Appendix H

Flood Modelling Report

260324 WAIRAKEI SOUTH SW MODELLING PEER REVIEW COMMENT REGISTER – SUMMARY SHEET

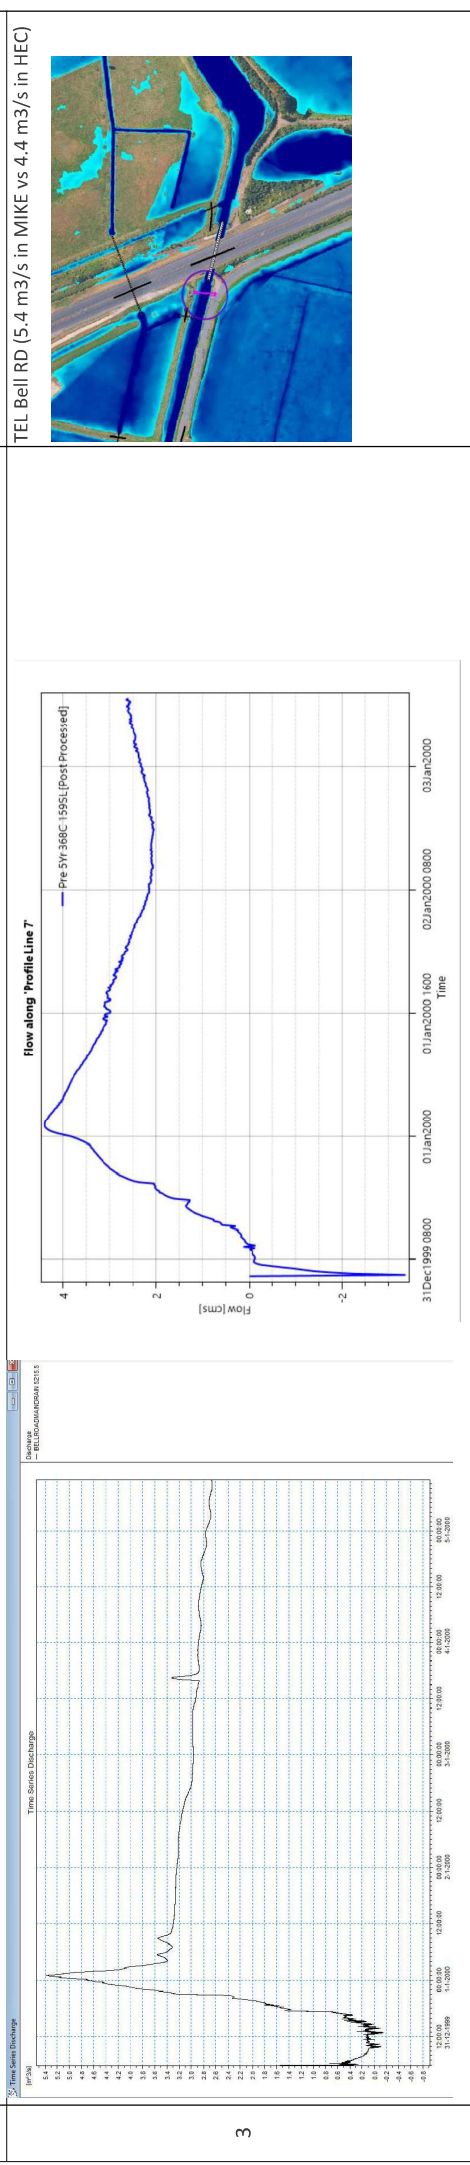
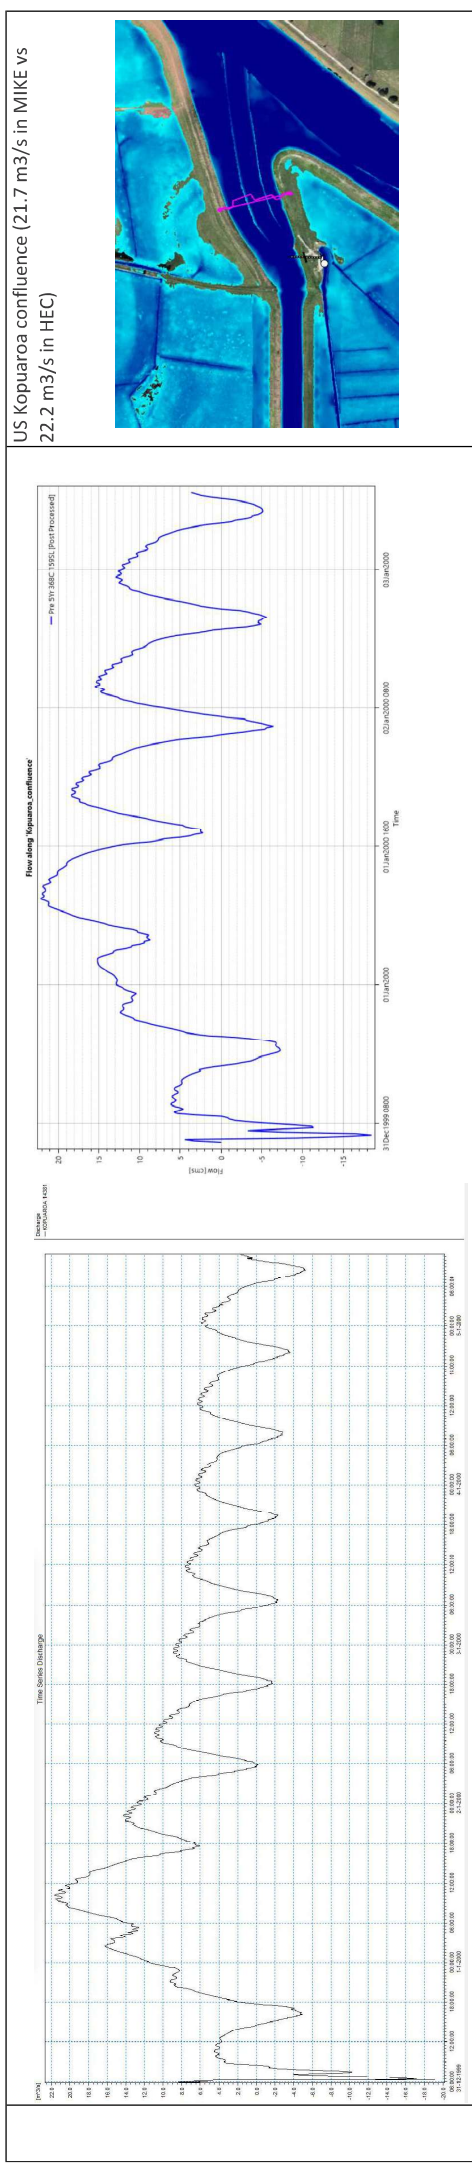
<p>US Kopuaroa : (17.1 m³/s in MIKE vs 17.6 m³/s in HEC)</p>

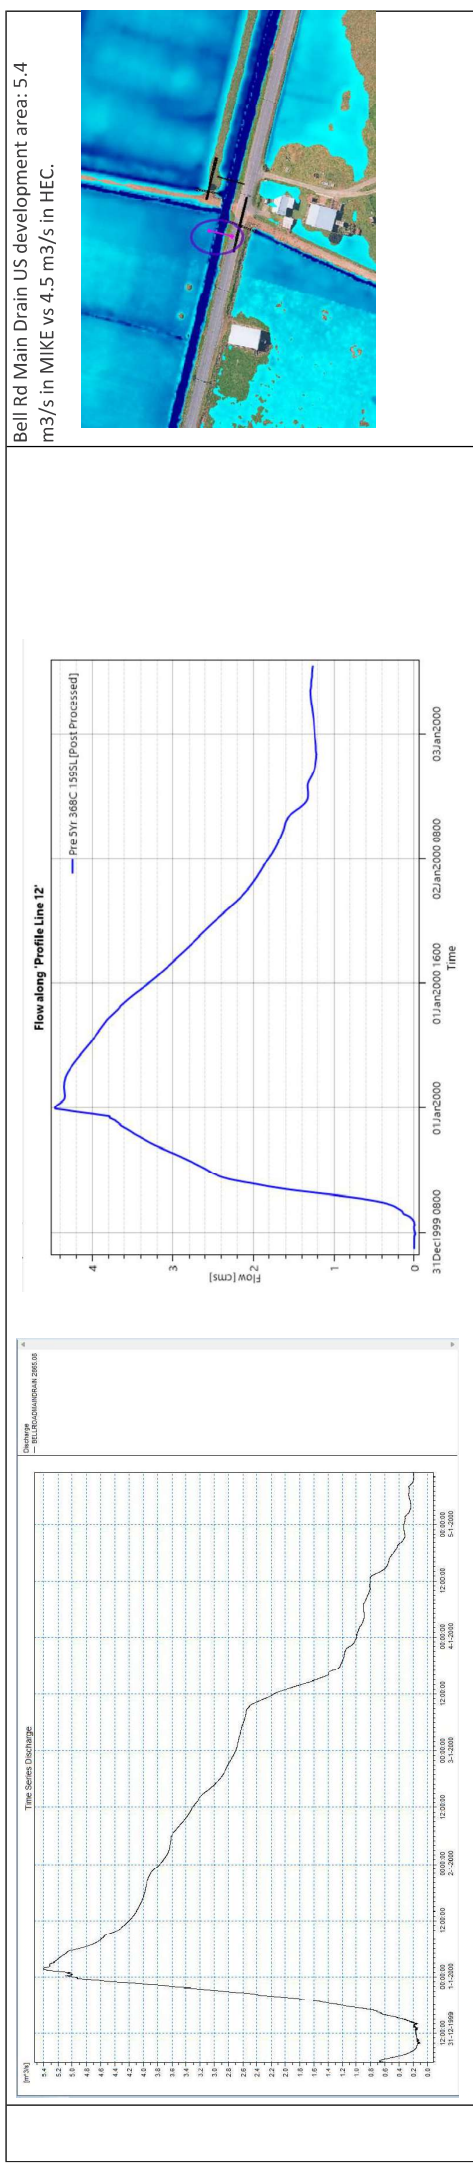
Bell Rd Main Drain 2072.9 : 8.1 m³/s in MIKE vs 5.6 m³/s in HEC.

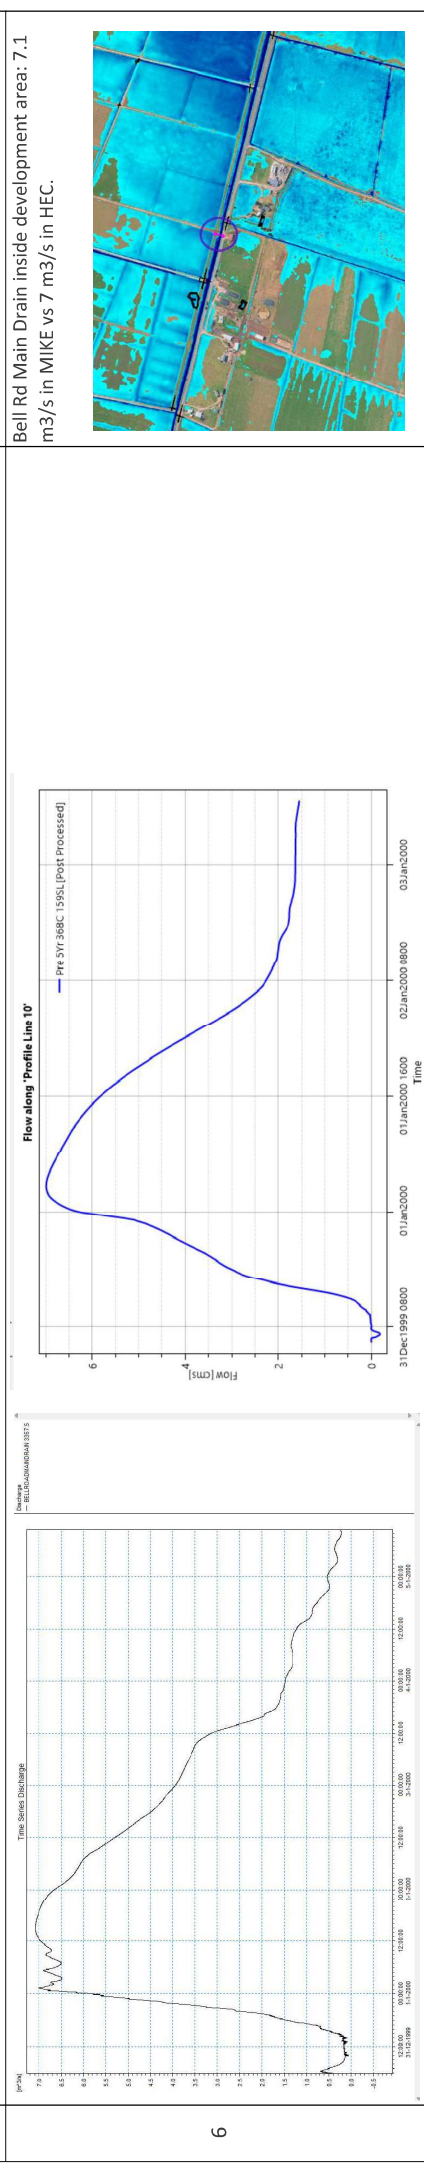
Bell Rd Main Drain US development area: 5.4 m³/s in MIKE vs 4.5 m³/s in HEC.

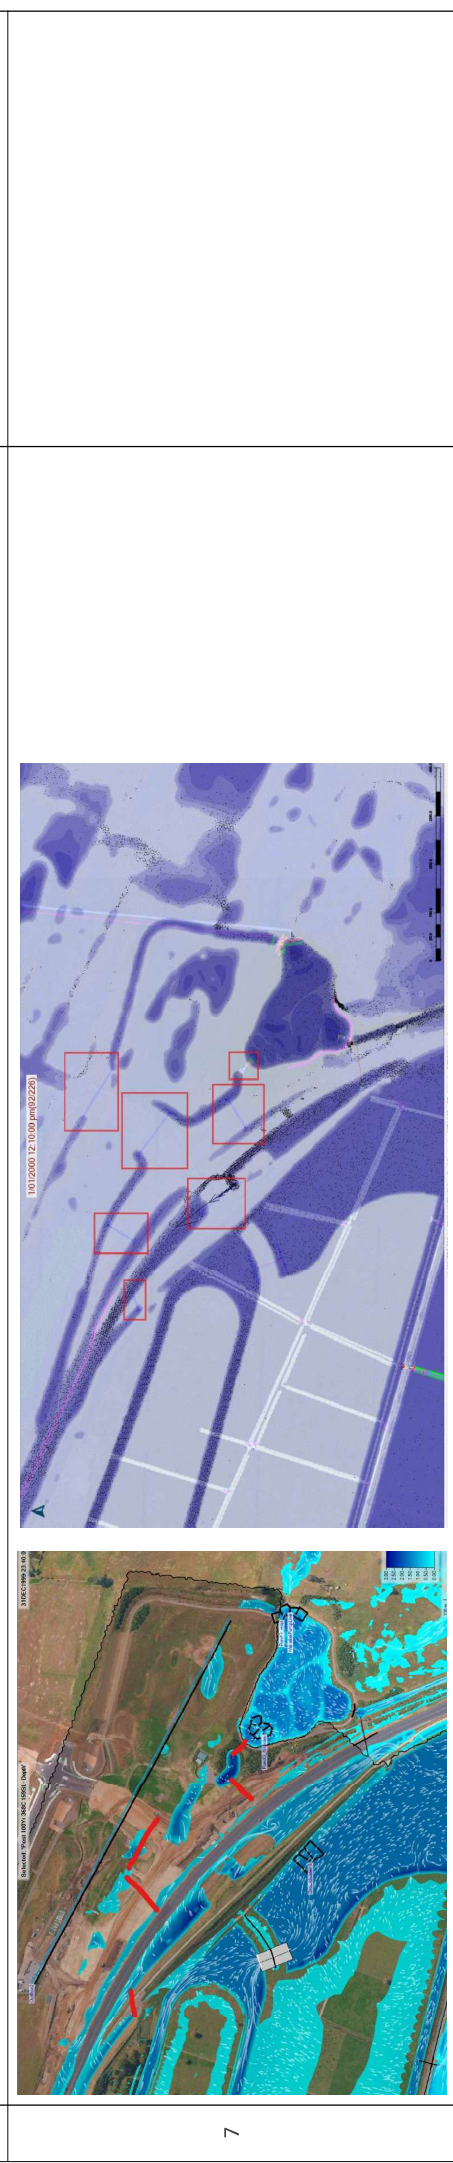
Bell Rd Main Drain inside development area: 7.1 m³/s in MIKE vs 7 m³/s in HEC.
